Re: 401 Water Quality Certification Application Response to Technical Comments
Vrooman Road
Corps Public Notice No. NA
Ohio EPA ID No. 144408

On behalf of the Lake County Engineer's Office (LCEO), Michael Baker Jr., Inc. is formally submitting a response to your e-mail dated September 22, 2014 regarding the Vrooman Road project. The intent of this submittal is to provide a technically sound and thorough permit application for your continued review and approval. Your comments followed by our responses are provided below.

**PREFERRED ALTERNATIVE
PROJECT STUDY AREA**

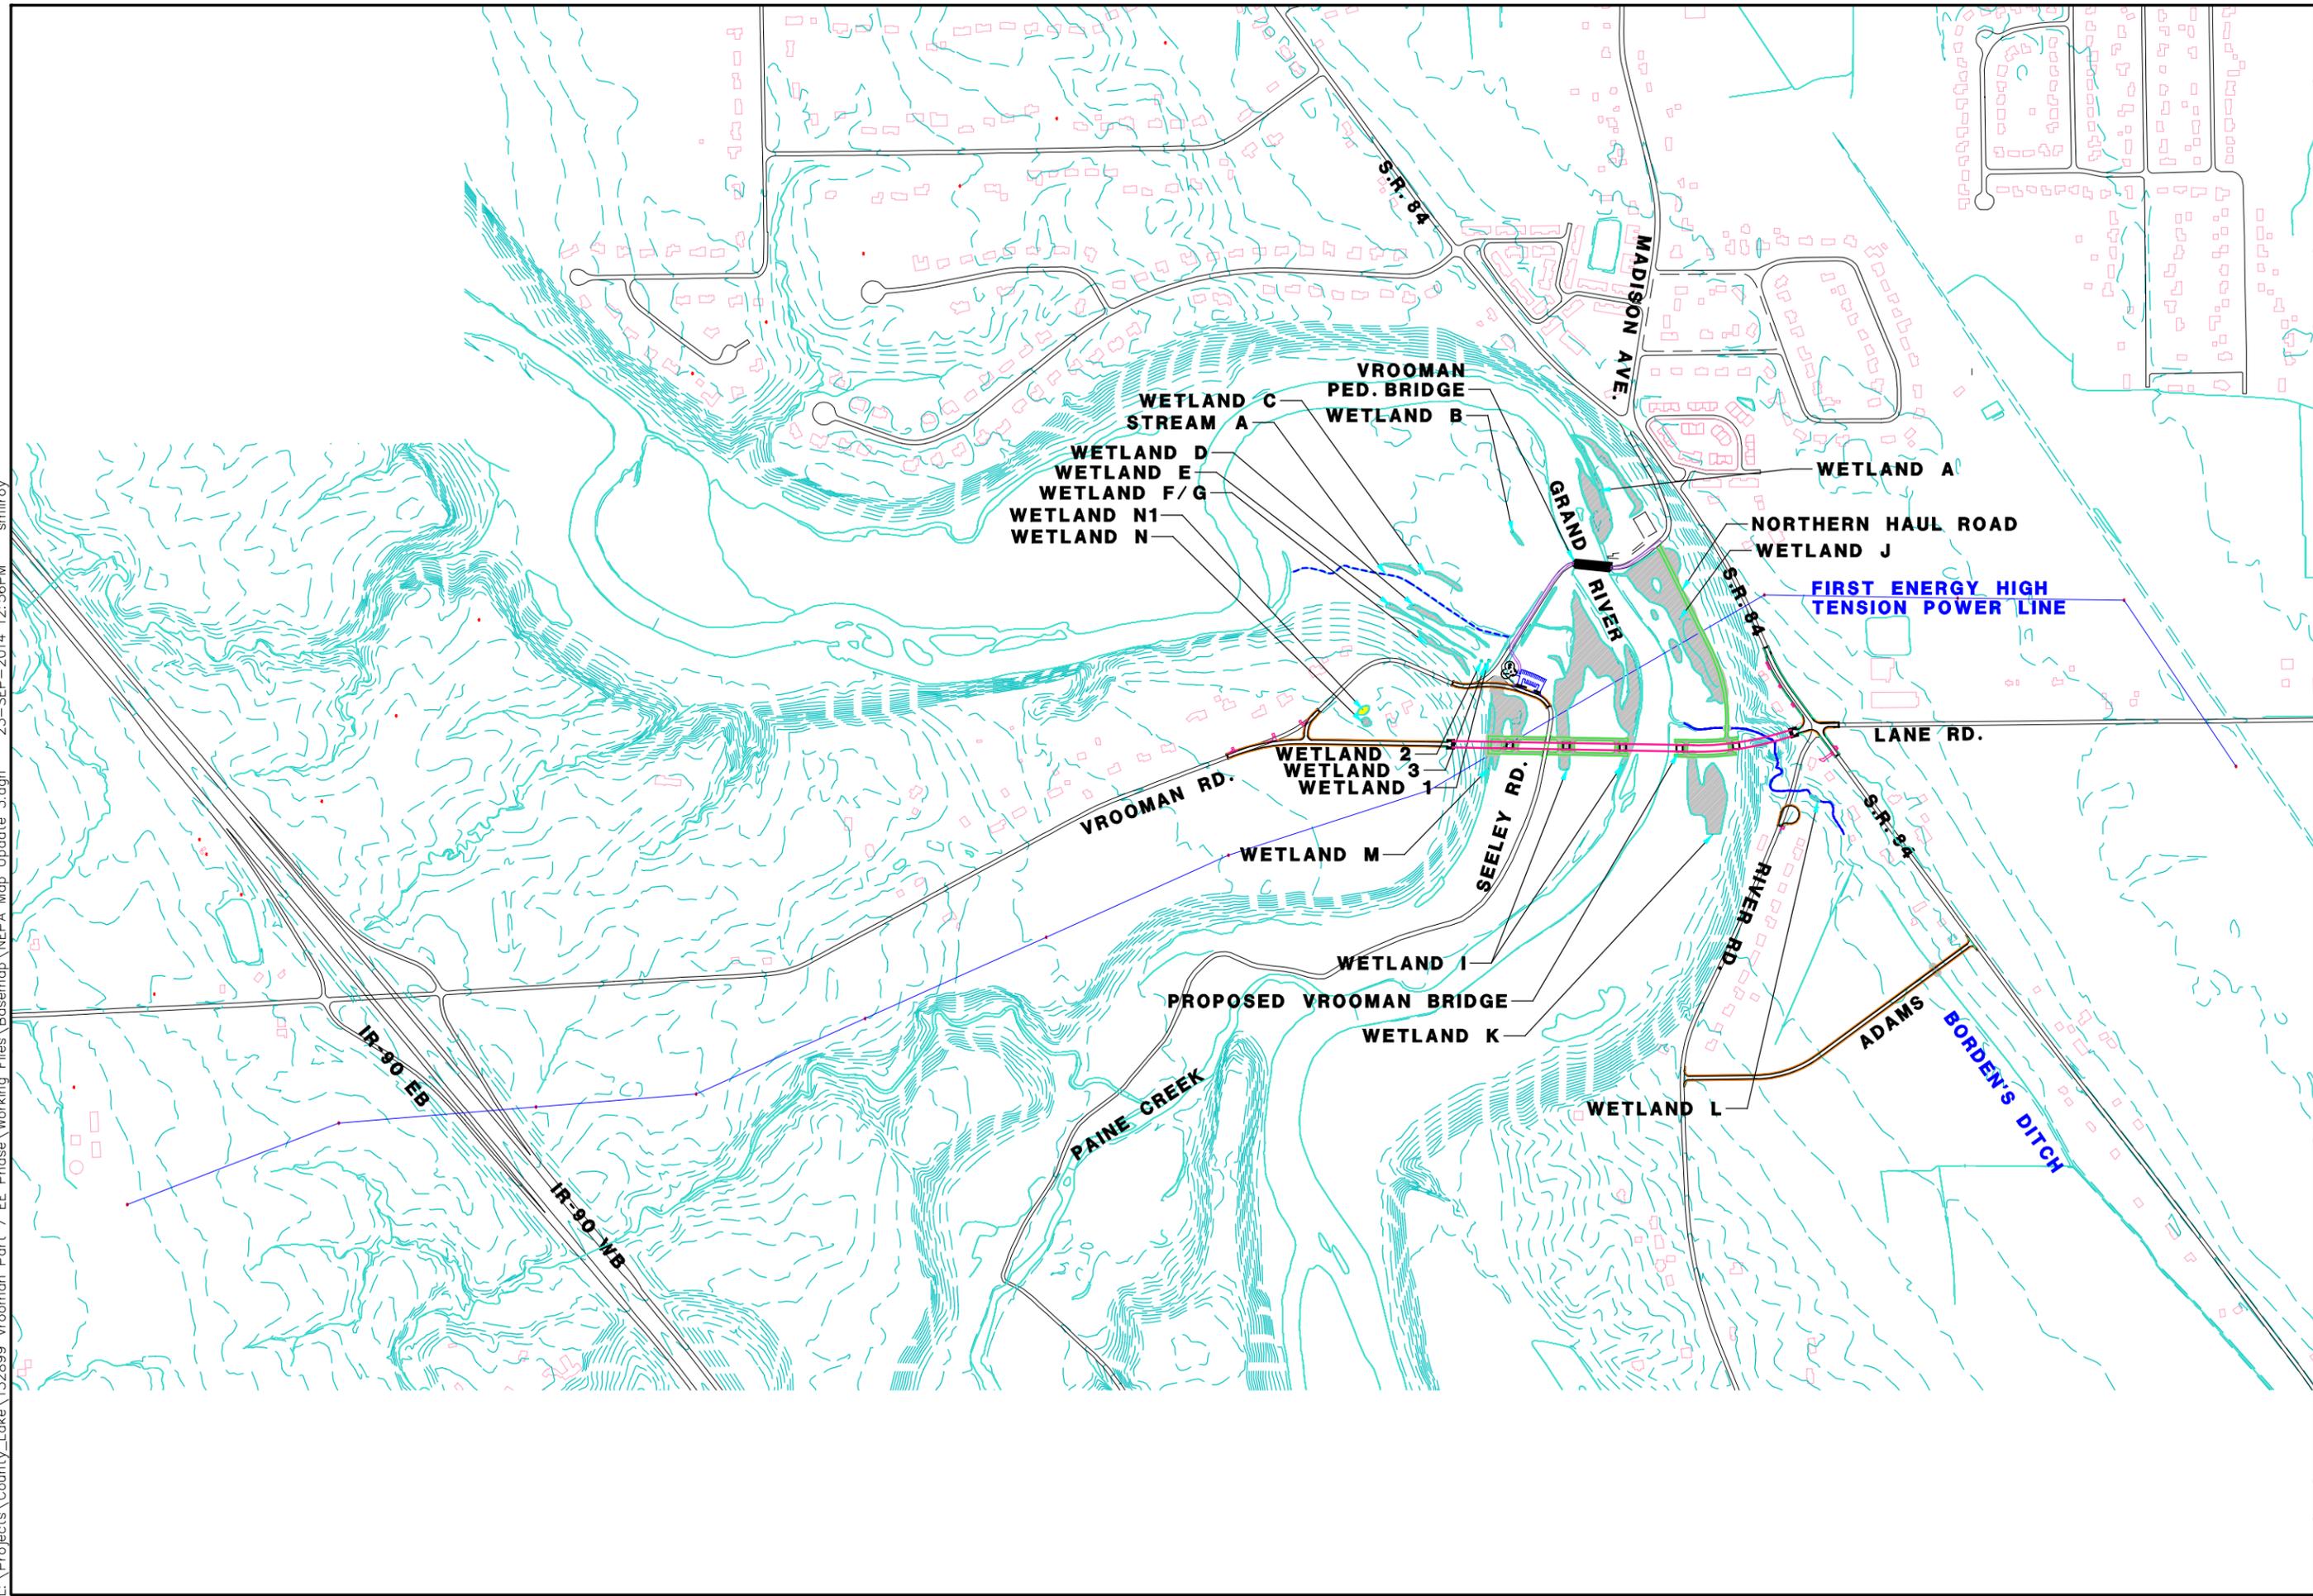
- 2. Please submit a set of drawings properly labeled “Preferred Alternative” and “Minimum Degradation Alternative.” These are primarily for getting good images for the Power Point presentation for the Public Hearing. Whithout the blue box listing the attributes, please (and green numbers).**

See attached drawings.
